CITY OF HOBART

City Infrastructure Committee Meeting

11 Sandy Bay Road Walking and Cycling Project - Request to Modify Design to Remove Pedestrian Crossing
File Ref: F17/34564; R0820/26

REPORT TITLE: SANDY BAY ROAD WALKING AND CYCLING PROJECT - REQUEST TO MODIFY DESIGN TO REMOVE PEDESTRIAN CROSSING

Figure 1 – 795 Sandy Bay Road, approved plan

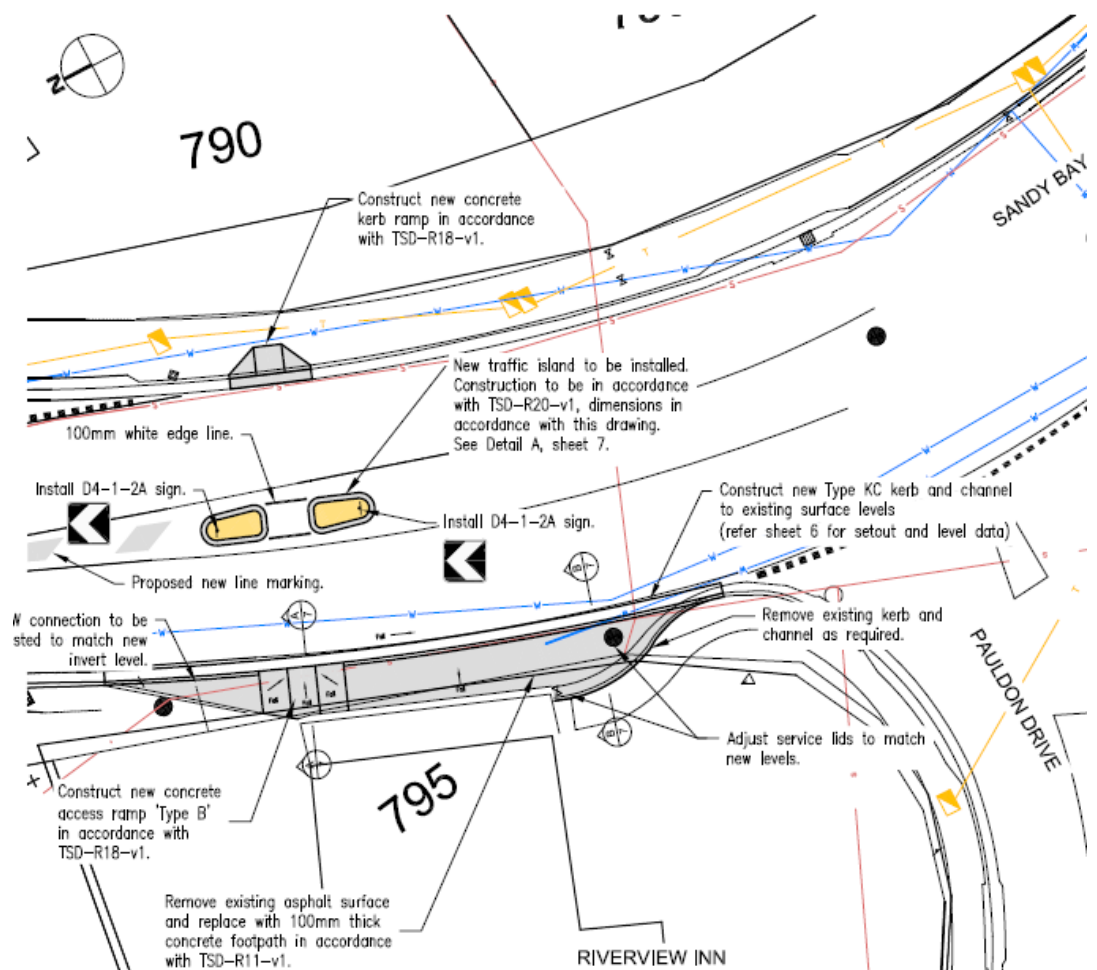
- 4.7. The proposed footpath, pedestrian refuge and pram ramps adjacent to 795 Sandy Bay Road are shown in Figure 1 below and require the removal of an indented parking area that can hold up to three cars. The proposed pedestrian facilities have been provided to allow for residents of Sandy Bay Road, Paldon Drive and Mitah Crescent to safely cross the road and are in close proximity to an existing bus stop pair on Sandy Bay Road.

1. In its consideration of the planning application for the Inn's extensions, Council planning officers were concerned to ensure provision for adequate vehicular parking for patrons was NOT disturbed. Indeed the view was that the extensions should not impact on the 3 car Spaces available at the front entrance. The finalised plans for the redevelopment were so determined.

2. The current cycle way plans not only eliminate these essential spaces but they also (and without our knowledge or approval) fall partly within the boundary of our land.

3. The very nature of ribbon development in the immediate area around this part of Sandy Bay Road of itself gives rise to an extremely low pedestrian density such that the deletion from the plan of a crossing adjacent to the Inn would not in any way diminish safety at this location. Convenient may be for a few, but essential, and in the most appropriate location, absolutely not.

We acknowledge there is to be a cycle way and its provision must be accommodated within reason at our frontage. We submit that our trading hours of 4.00pm until late should be able to allow for our essential parking at these times notwithstanding the spaces will include part of the cycle way.

Northern cycle movements occur in the main in times outside these times and it should be possible for Council to provide adequate signage limiting this small but necessary parking area to times within our business hours only.

- 4.10. The continuation of the footpath and provision of a pedestrian refuge island is an important aspect of this project. Alternative locations for a pedestrian refuge island were considered but the windy nature of Sandy Bay Road meant that adequate sight distance for pedestrians was not achievable. Adequate sight distance for pedestrians can be achieved at the proposed refuge location.

- 5.1. Pedestrian amenity and safety is a higher priority than the provision of on-street car parking. On that basis, it is proposed to complete the approved works for Stage 3 of the Sandy Bay Walking and Cycling project – including the footpath extension, pedestrian refuge and pram ramps adjacent to 795 Sandy Bay Road.
